SUBJECT: ISSUANCE OF AMENDMENT NOS. 48 AND 37 TO FACILITY OPERATING LICENSE NOS. NPF-76 AND NPF-80 - SOUTH TEXAS PROJECT, UNITS 1 AND 2

(TAC NOS. M84618 AND M84619)

ATTACHMENT TO LICENSE AMENDMENT NOS. 48 AND 37 FACILITY OPERATING LICENSE NOS. NPF-76 AND NPF-80 DOCKET NOS. 50-498 AND 50-499

SAFETY EVALUATION BY THE OFFICE OF NUCLEAR REACTOR REGULATION

REQUIRED SHUTDOWN MARGIN VERSUS RCS CRITICAL BORON CONCENTRATION

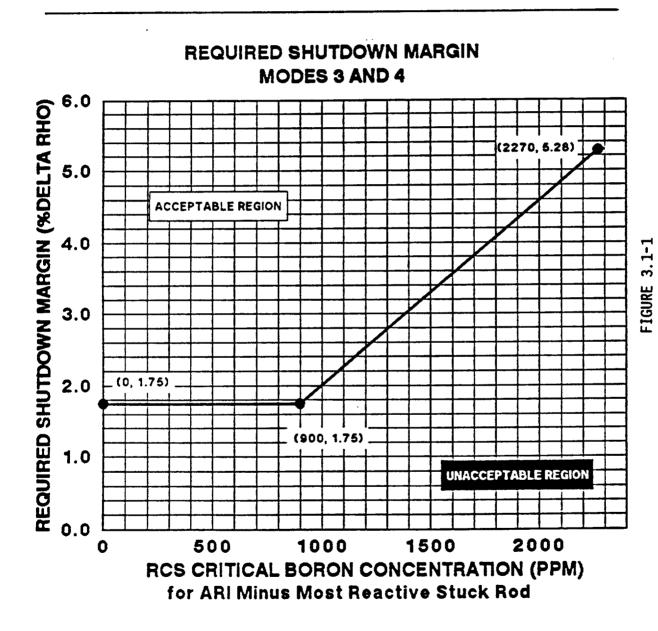
The amendments change the Appendix A Technical Specifications by: (1) replacing the variable shutdown requirements (TS Figure 3.1-1) with a constant value; and (2) changing surveillance requirement TS 4.1.1.1.2 clarifying reactivity balance calculations to confirm core design predictions, leading to the validation of shutdown margin.

The licensee has also proposed a change to surveillance requirement, TS 4.1.1.2, clarifying reactivity balance calculations to confirm core design predictions, leading to the validation of shutdown margin. The proposed changes will modify figure 3.1-1 of TS 3.1.1.1 and change the text of TS 4.1.1.1.2. These changes will only impact MODES 1 and 2, and will have no impact on MODES 3 and 4.

The presence of the variable shutdown margin requirements for MODES 1 and 2 places an undue restriction on the design of the reactor core at beginning-of-life (BOL) conditions. The present use of Figure 3.1-1 (TS 3.1.1.1), suggests that additional shutdown margin over and above the constant value of 1.75% delta rho is required for critical boron concentrations over 900 ppm. The safety analyses were performed using a constant shutdown margin of 1.75% delta rho, consequently, the change to figure 3.1-1 will reflect the use of the constant shutdown margin of 1.75% delta rho in the safety analyses. Similarly, the proposed change to Figure 3.1-1 will not reduce the margin of safety for MODES 1 and 2.

In MODES 3 and 4, the most restrictive condition occurs at BOL when the boron concentration is greatest. In MODES 3 and 4, the required shutdown margin is composed of a constant and a variable requirement. The variable portion is a function of the RCS boron concentration. The constant shutdown margin requirement of 1.75% delta rho is based on an uncontrolled RCS cooldown from a steamline break accident. The variable shutdown margin requirement is based on the results of a boron dilution accident analysis, whereby the shutdown margin is varied as a function of RCS boron concentration, to guarantee a minimum time for operator action after a boron dilution alarm. Consequently, the above analysis suggests that the shutdown margin requirements for MODES 1 and 2 are separable from those for MODES 3 and 4. It should be pointed out that the change to Figure 3.1-1 does not constitute a change to the design basis of South Texas Units 1 and 2, since the design limits for MODES 1 and 2 remain at 1.75% delta rho. The change to Figure 3.1-1 is acceptable.

REQUIRED SHUTDOWN MARGIN FOR MODES 1 AND 2:

1.75% DELTA RHO
